**DRAFT RESPONSES TO U.S. DOE COMMENTS
ON DRAFT 881 HILLSIDE AREA FEASIBILITY STUDY
VOLUME 1, DATED 1 MARCH 1988**

**Figure 3-3:
Generalized East-West Cross Section
Front Range to Denver Basin**

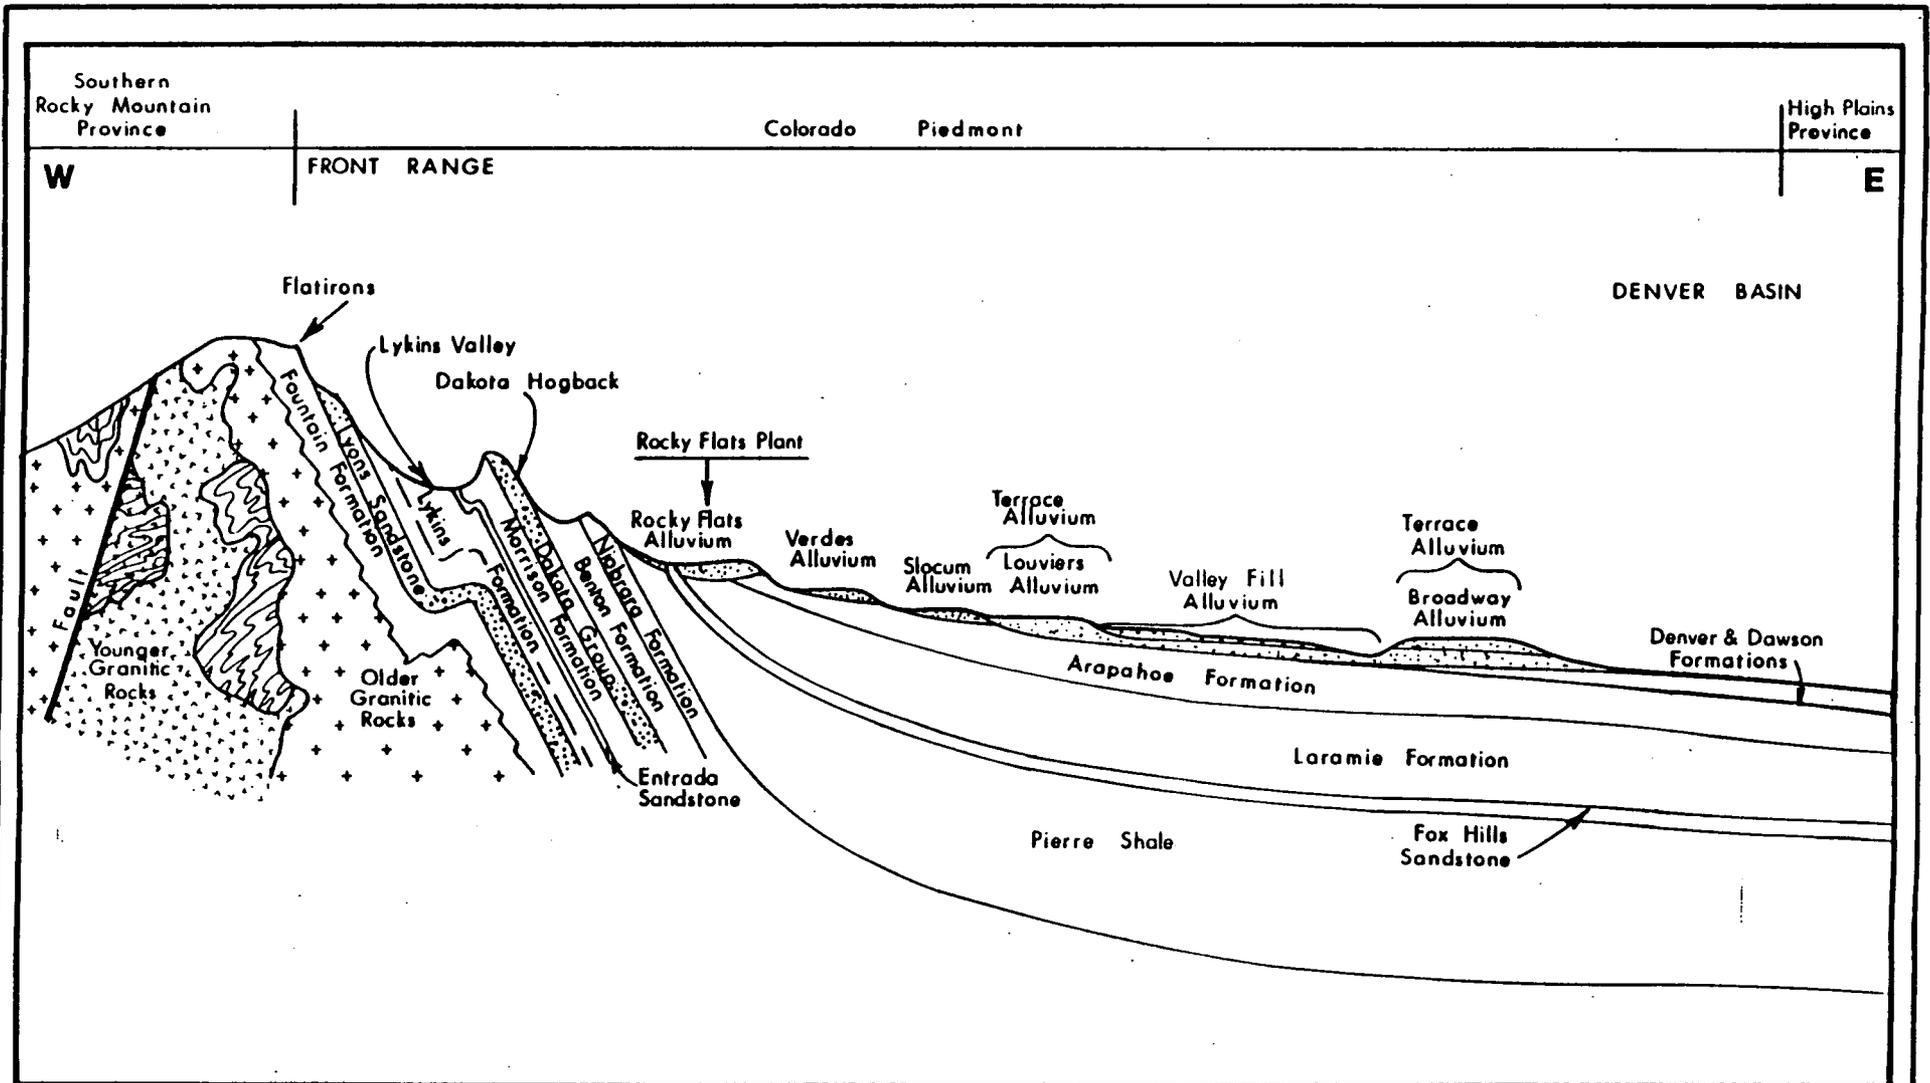
The Fountain Formation is not shown in Figure 1-5 as stated.

There are 2 Upper Laramie Formations indicated. Perhaps one should be the Arapahoe Formation, which is not shown here; Laramie is misspelled.

The Fountain Formation is not shown on Figure 1-5. The following figures are a generalized east-west cross section and stratigraphic section which will replace Figure 1-5 in the revised FS report. These illustrations are more applicable for the discussion which follows in the Report.

Yes, there are two Upper Laramie Formations indicated in Figure 1-5. Ka should be the Cretaceous Arapahoe and Laramie is misspelled. We intend to replace this cross section with the illustrations indicated for the previous response.
